Rezoning Transportation Analysis

Petition Number: 2020-071

Date	Description
07-22-20	First Review

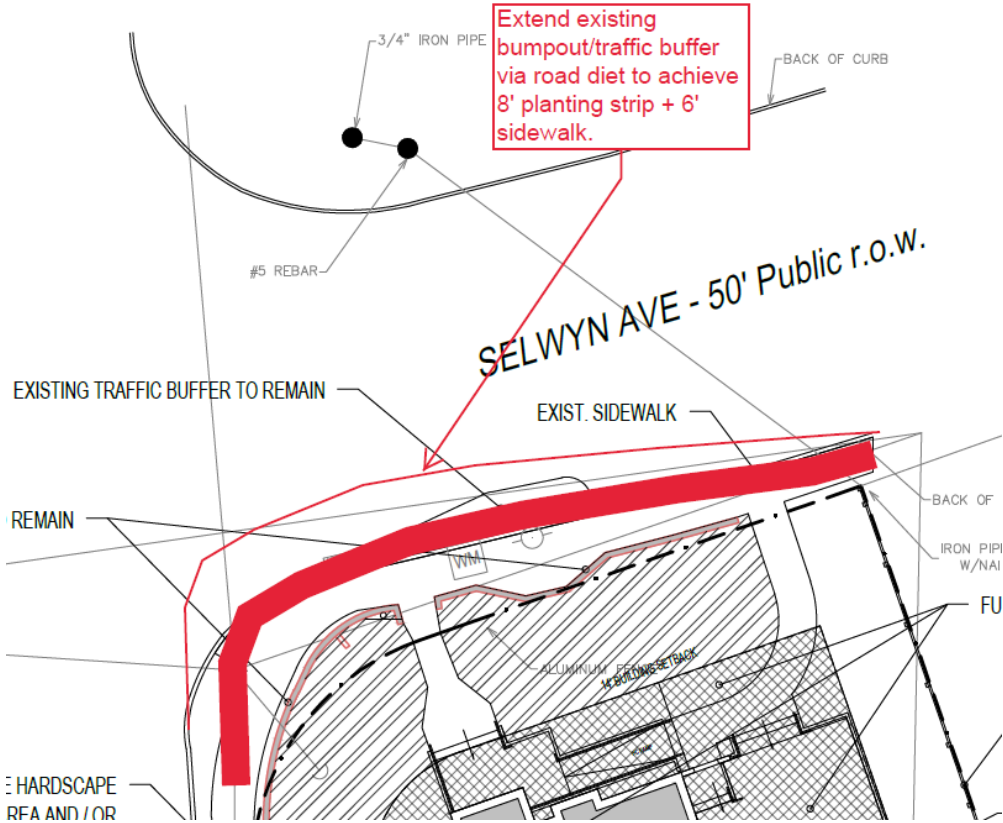
- Curblin**e The proposed zoning district has a setback measured from back of the existing or proposed future curblin

- Park Road**: The future location of curb and gutter is in its existing location.
 - Selwyn Avenue**: The future location of curb and gutter is in its existing location.

The site plan should show the curb and gutter labeled and dimensioned from the centerline for each road.

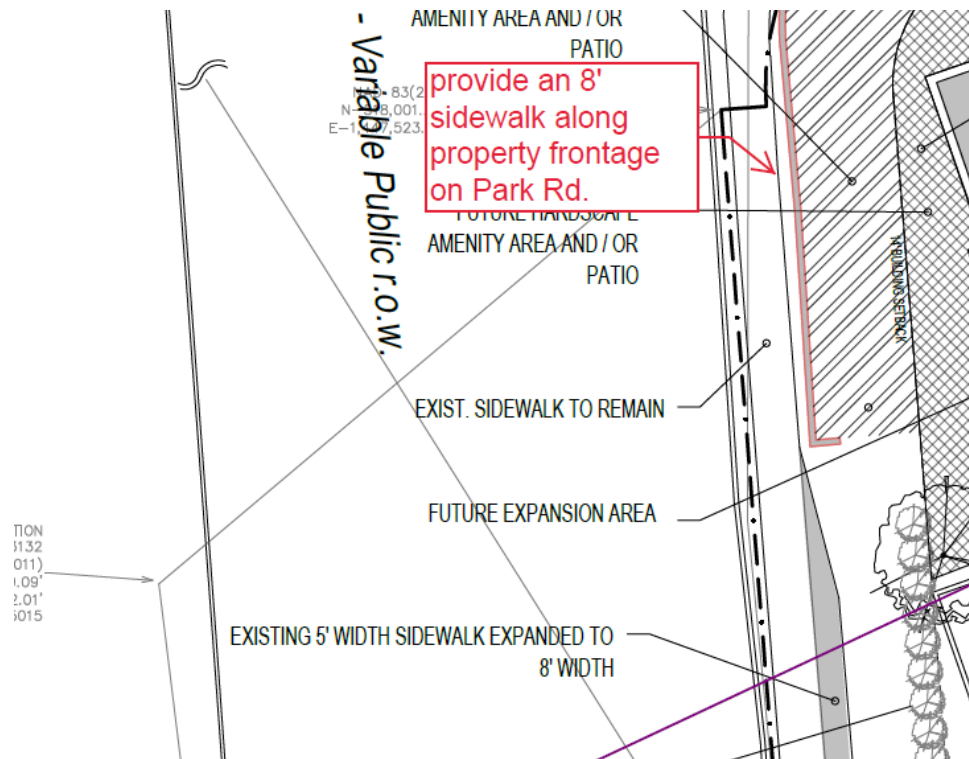
- 5. The petitioner should revise the site plan and conditional note(s) to commit to constructing an 8-foot sidewalk along the Park Road frontage per Chapter 19th. The site plan should label and dimension both items from the back of curb and gutter and road centerline.

6. The petitioner should revise the site plan to add a note specifying dedication and fee simple conveyance of all rights of way to the City before the site's first building certificate of occupancy is issued. CDOT requests right of way set at 2' behind back of sidewalk where feasible.
7. The petitioner should revise the site plan to add a note specifying all transportation improvements will be approved and constructed before the site's first building certificate of occupancy is issued. The petitioner may phase transportation improvements if said improvements and phasing are explicitly described in site plan notes.
8. ~~Resolved-Sample format for comment that is resolved~~
